UNITED STATES PATENT AND TRADEMARK OFFICE

APPLICATION NO.	FILING DATE	FIRST NAMED INVENTOR	ATTORNEY DOCKET NO.	CONFIRMATION NO.
10/814,331	04/01/2004	Ray C. Minor	P69605US0	5342

Office Action Summary

DETAILED ACTION

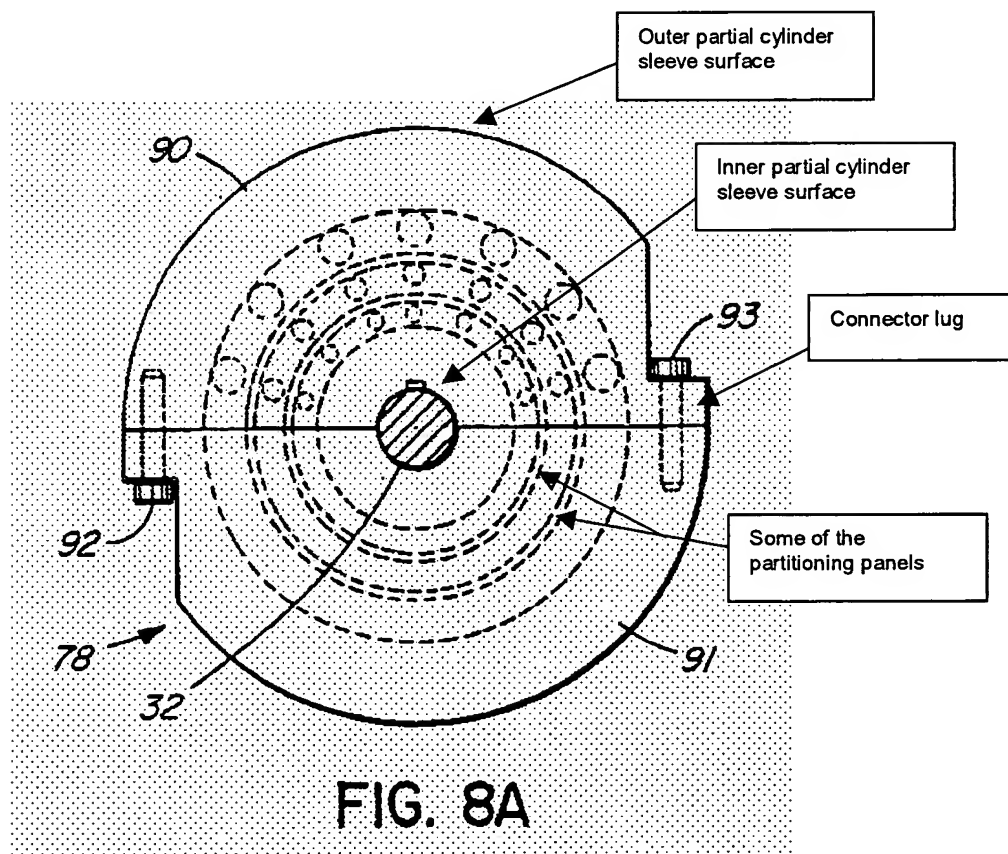
Re: claims 33, 37, and 38. Hannah et al. show in figure 8A pole a vibration damping assembly mountable on a pole 32 capable of damping wind induced first harmonic mode pole vibrations, said assembly comprising an annular housing including a first housing component half-portion 90 and a second housing component half-portion 91 and connections 92, 93 connecting the first housing component half-portion to the second housing component half-portion, each housing component half-portion including an inner partial cylinder having an inner partial cylinder sleeve surface as labeled in the

drawing on the following page having a lower portion, a center of curvature and being dimensioned and shaped to fit in a mating manner over, and in facing contact with, an upper end portion of a pole having an axis approximately coextensive with the center of curvature of the pole as shown, an outer partial cylinder sleeve positioned outwardly of the inner partial cylinder sleeve surface and having a lower end portion and a center of curvature that is coextensive with the center of curvature of the inner partial cylinder sleeve surface as shown, a floor panel shown below the balls extending between lower portions of the inner partial cylinder sleeve surface and the outer partial cylinder sleeve, a plurality of partitioning panels shown radially between the balls extending vertically upwardly from the floor panel and extending between the inner partial cylinder sleeve and the outer partial cylinder sleeve to define damping weight receiving chambers between adjacent partitioning panels and a movable damping weight or balls in each of the damping weight receiving chambers as shown.

Hannah et al. show some of the partitioning panels, but fail to show the damping weight receiving chambers being non-circular.

Re: claims 44, 45, and 50. Hannah et al., as modified, show in figure 8a a vibration reducing device mountable on a pole 32 capable of damping wind induced first harmonic mode vibrations comprising a housing mountable on a pole and including an annular array of dry weight receiving chambers or annular areas in which the balls are located shaped and dimensioned to encircle and effect mounting of the device on a pole, a damping weight or spherical balls in each dry weight receiving chamber and, wherein, the dry weight receiving chambers are separated by structure or partitioning panels as shown preventing movement of the damping weights from one dry weight receiving chamber to an adjacent dry weight receiving chamber.

Re: claims 41-43. Hannah et al., as modified, show in figure 8A wherein the first housing component half-portion and the second housing component half-portion are fixedly connected together to cooperatively encircle the cylindrical pole, each housing component half portion includes a first planar plate extending between a first end portion of the inner partial cylinder sleeve and a connector lug labeled in the labeled version of figure 8A found earlier in the office action comprising part of the connection on a first end portion of the outer partial cylinder sleeve, and a second planar panel

extending between a second end portion of the inner partial cylinder sleeve and a connector lug as labeled comprising part of the connection on a second end portion of the outer partial cylinder sleeve and threaded screws comprising part of the connection connecting the connector lug of the second housing component half portion to provide a rigid housing structure.
